WEST SUSSEX COUNTY COUNCIL CONSULTATION

TO:	Arun District Council Ross Leal
FROM:	Debbie Farrell WSCC County Highways
DATE:	14/3/18
SUBJECT:	FG/33/18/PL Demolition of polytunnels, use of land for Class B8 container self-storage & the siting of 42 No. single-stacked storage containers, an office/toilet portacabin, new fencing, gates, CCTV, lighting & alterations to the entrance. Land at former McIntyre Nursery, Littlehampton Road, Ferring, BN12 6PG
DATE OF SITE VISIT:	
RECOMMENDATION:	☐ Advice ☐ Objection ☐ Modification ☒ No Objection ☒ More Information ☐ Refusal
S106 CONTRIBUTION TOTAL:	TBC

**Re: Land at the former McIntyre Nursery, Littlehampton Road, West Sussex BN12 6PG
Demolition of polytunnels, use of land for Class B8 container self-storage and the
siting of 42 single-stacked storage containers, an office/toilet portacabin, new fencing,
gates, CCTV, lighting and alterations to the entrance.**

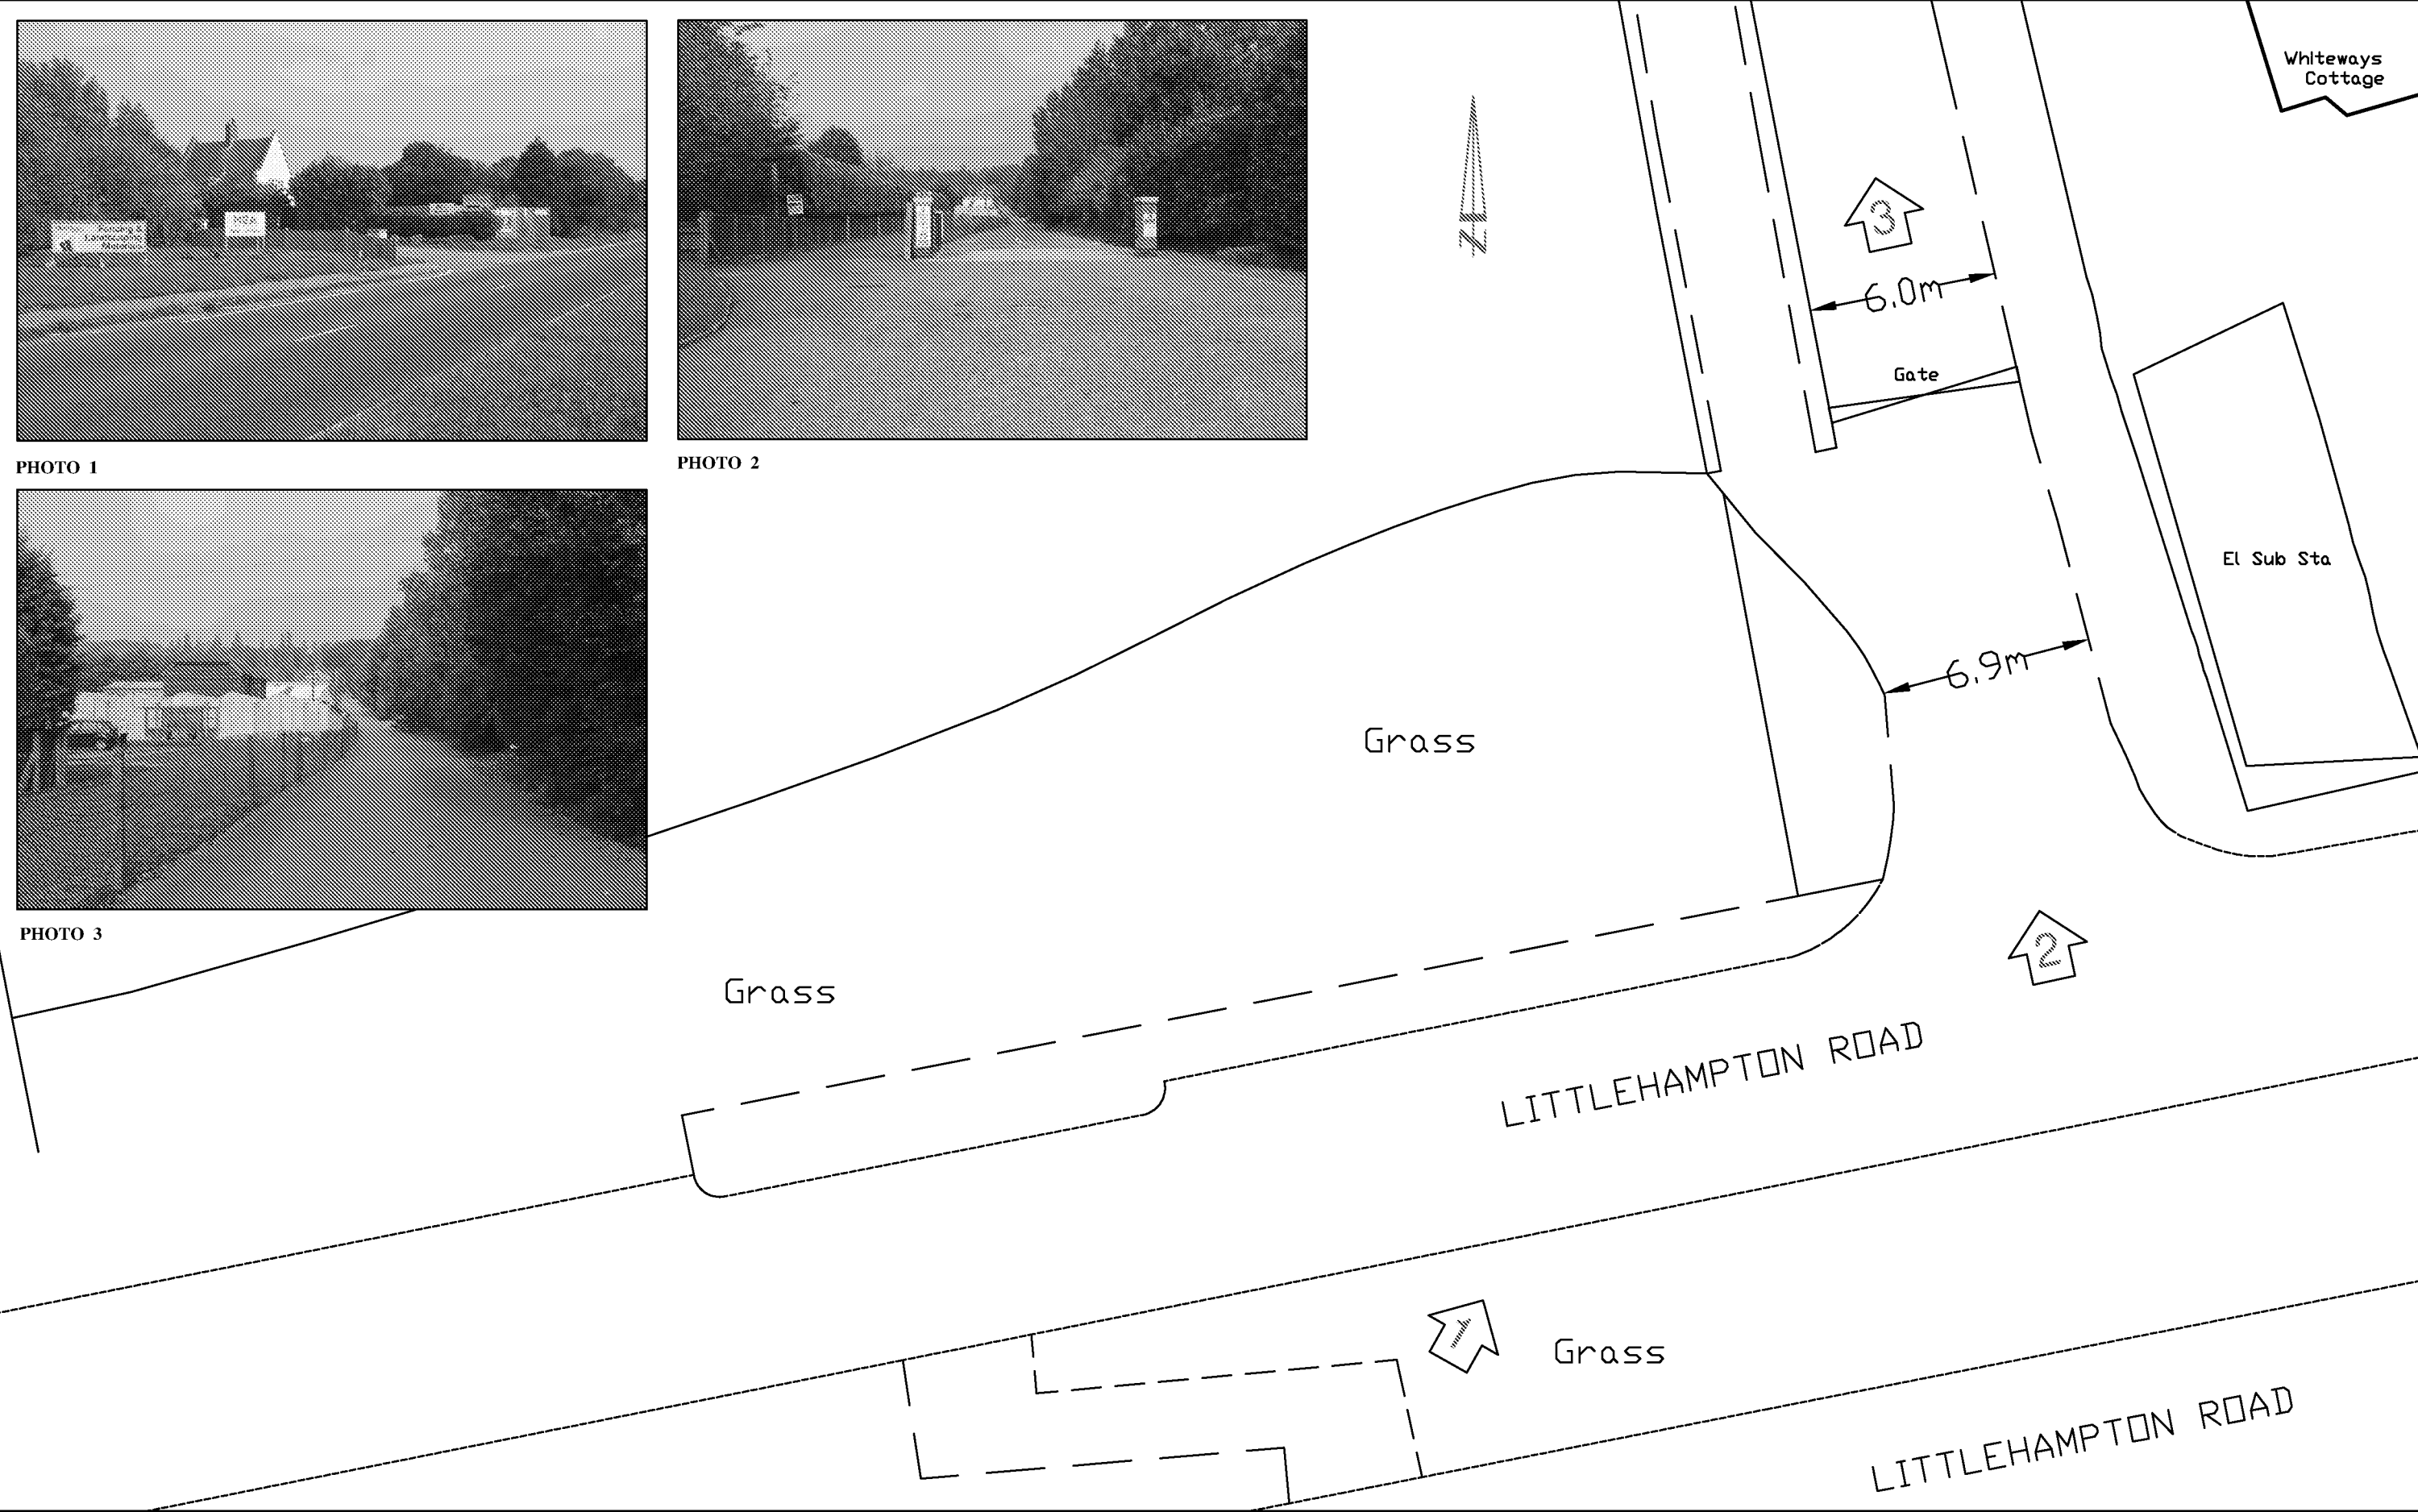
No information has been provided on how the containers will be delivered/removed from the site ie on what sort of vehicle. It is advised that

the applicant consider this to ensure there is sufficient room for large vehicles to turn into the site (from the public highway) and exit safely without impacting on the public highway. Can the applicant please provide details of how the containers will be delivered and a plan showing swept paths of the delivery vehicle manoeuvring into and out of the access with the A259. Consideration of how a large vehicle will manoeuvre within the site in order to re-enter the site in a forward gear is also required.

The applicant proposes to deliver (and eventually remove) the containers using a 7.5 ton flat-bed rigid lorry. This small lorry has a 20' loadspace, sufficient to accommodate a standard 20' shipping container (6.06 x 2.11m). A small mobile crane would manoeuvre the container into the required position.

It is proposed to reconfigure the site entrance in order to improve access for a 7.5T flat-bed. The proposed site plan shows a 9m radius hammerhead entrance. The container delivery lorry would perform a reverse side turn into the site from the main access road and eventually exit the site in forward motion. The 9m radius turning circle and 6.11m width of the access road conform with, or exceed, standard highway geometry, rendering a swept path analysis superfluous. The new access point would also offer improved sight lines.
